**REQUEST FOR WAIVER FROM ACCESSIBILITY REQUIREMENTS
OF CHAPTER 553, PART II, FLORIDA STATUTES**

Name: High Reach 2 Office and Maintenance Facility

Address: 260 Hickman Drive Sanford, FL 32771

OFFICE SECOND FLOOR PLAN

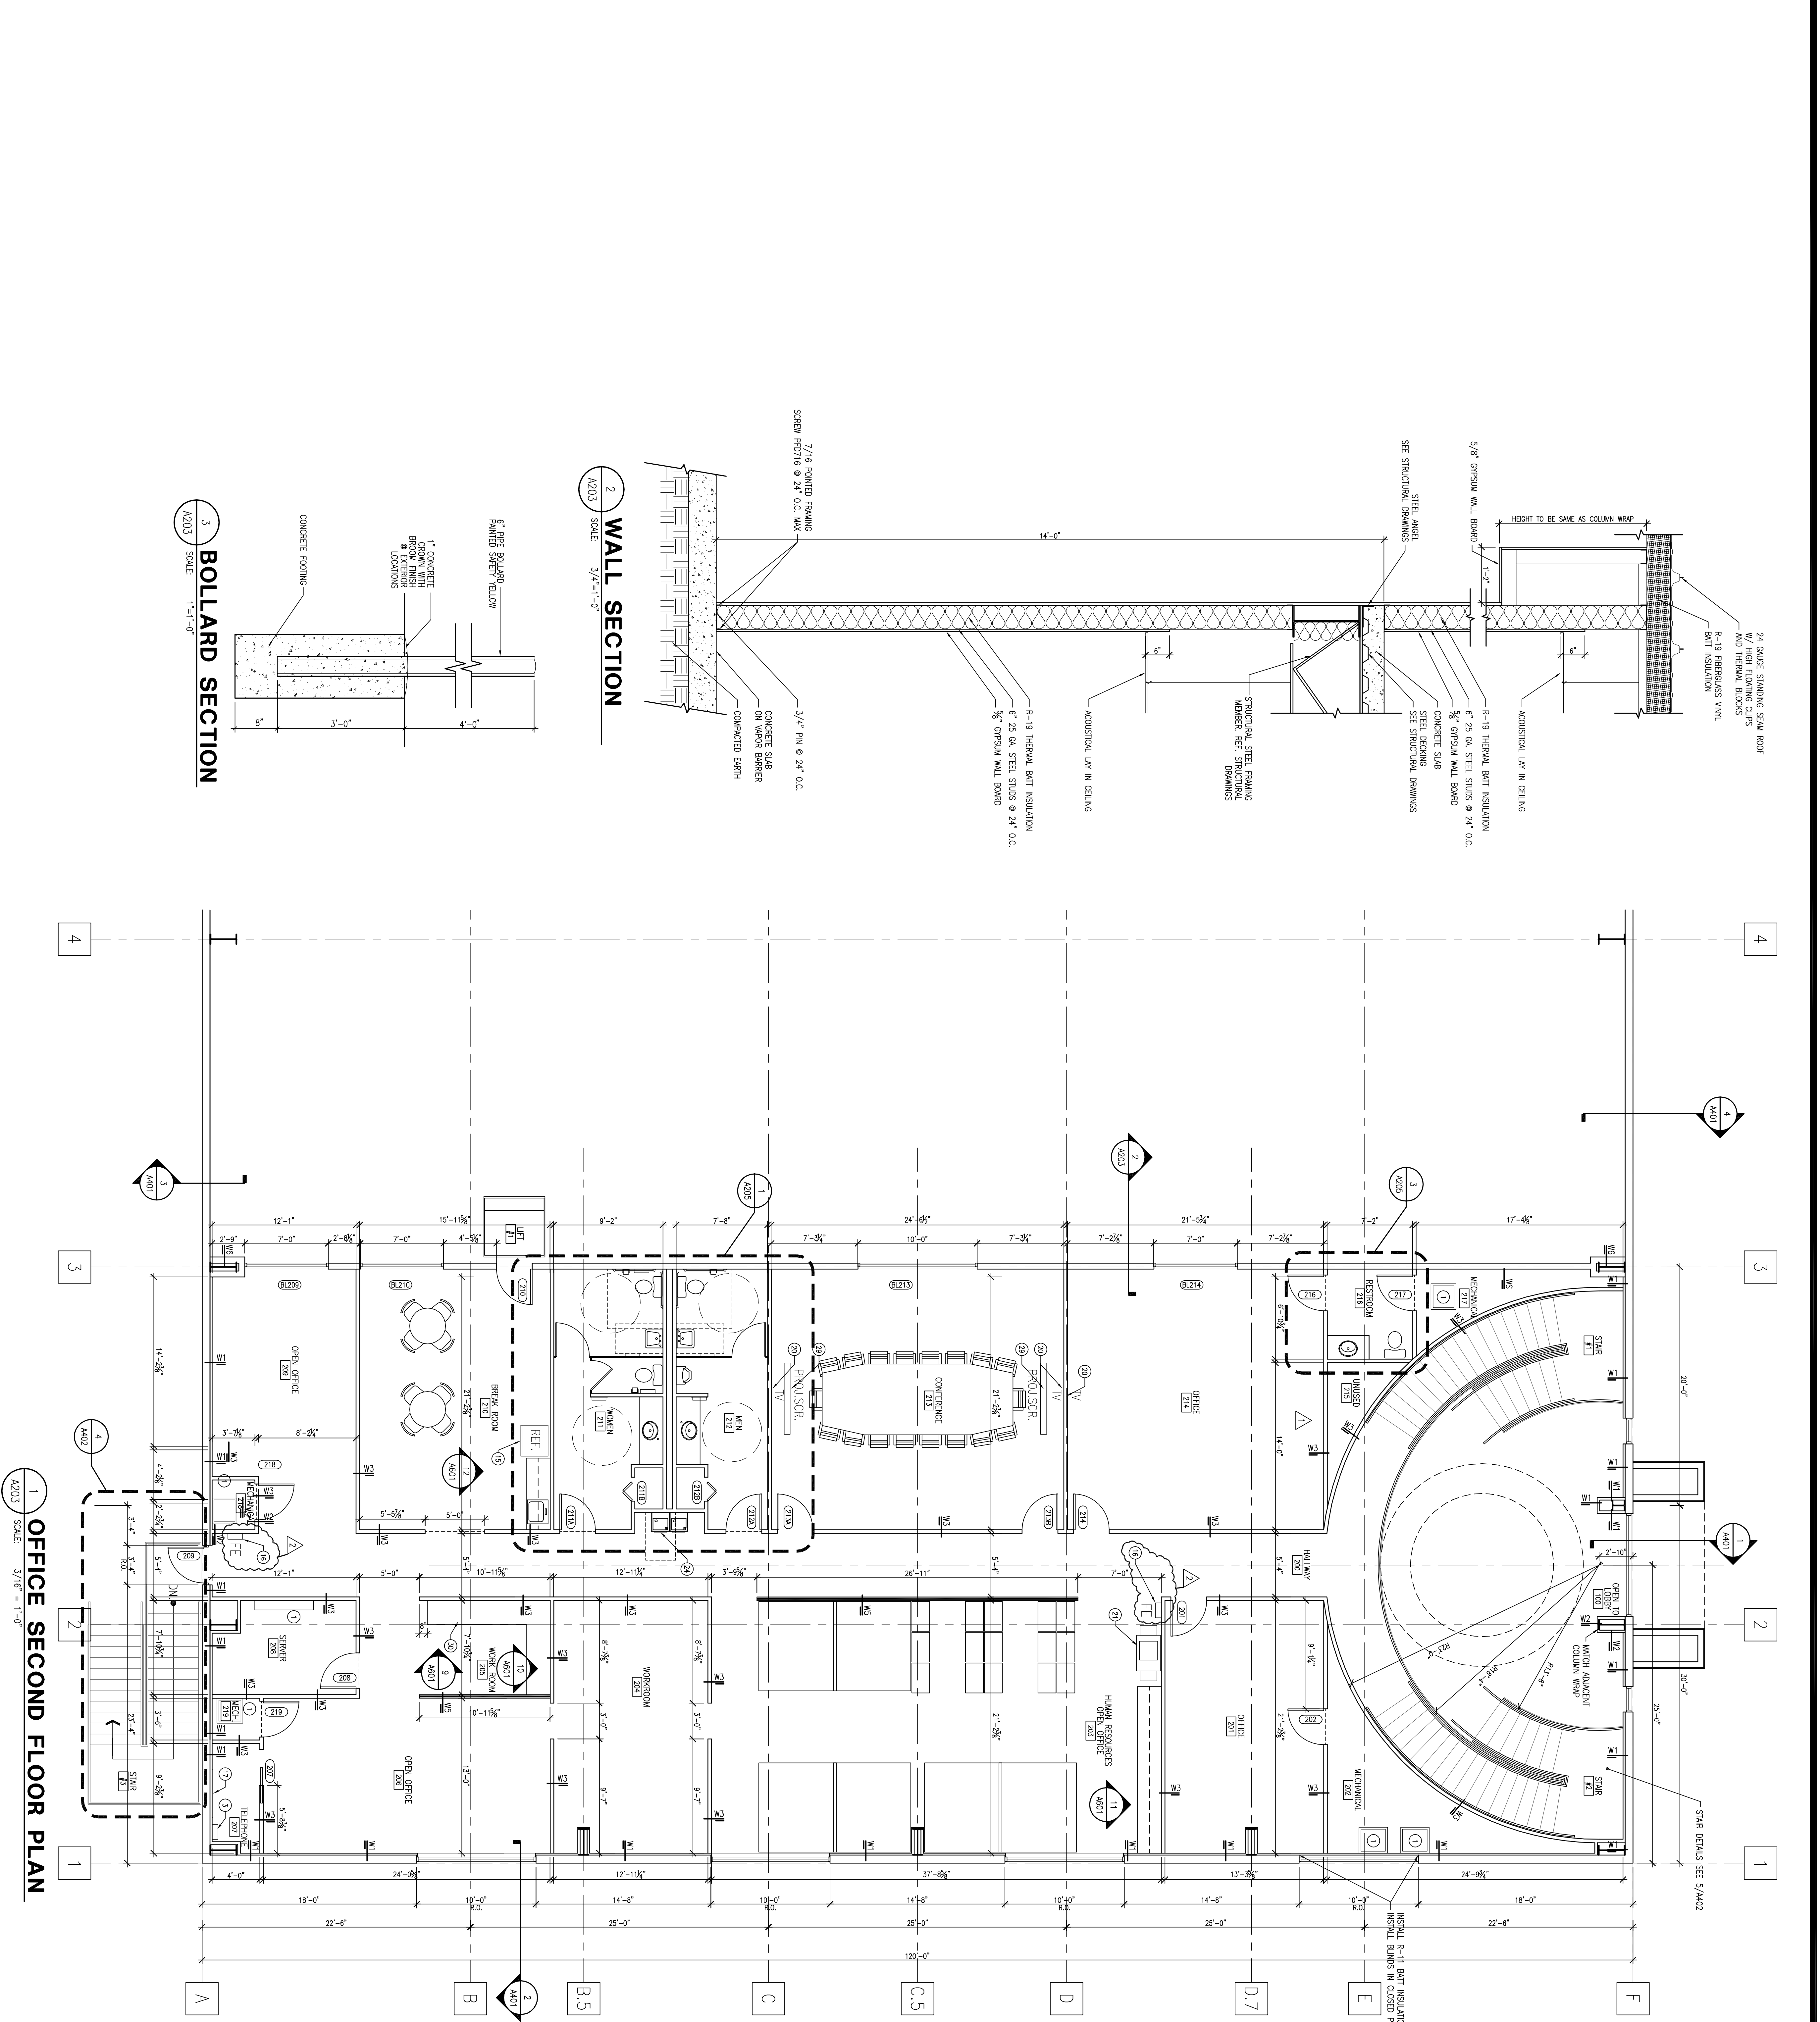
1: Ref: Section 206.7.1 thru 206.7.10 Florida Accessibility Code 2012 Edition. These codes outline specific situations where a platform lift may be used. The use of the platform lift in this project does not fit into any of these categories. However, this project meets the federal elevator exemption, as the facility is less than three stories. The intent of the Florida Accessibility Code is to allow a platform lift as a component of an accessible route for the second floor of the office area.

In my review of the requirements and the intent of the code, it is my professional opinion that a platform lift would be allowed to be used as a part of an accessible route to the second floor of the office area per 206.7 of the Florida Accessibility Code and the Federal Elevator Exemption.

- a. Sec.206.6 states the requirements of an elevator, exception 1 permits platform lifts
- b. per section 206.7 but per 206.7 the size and use of the 2nd floor office space does
- c. not meet the uses allowed for a platform lift.

Comments/Recommendation We referred them to your board as we cannot find a
code path to allow the use of a platform lift for this project.
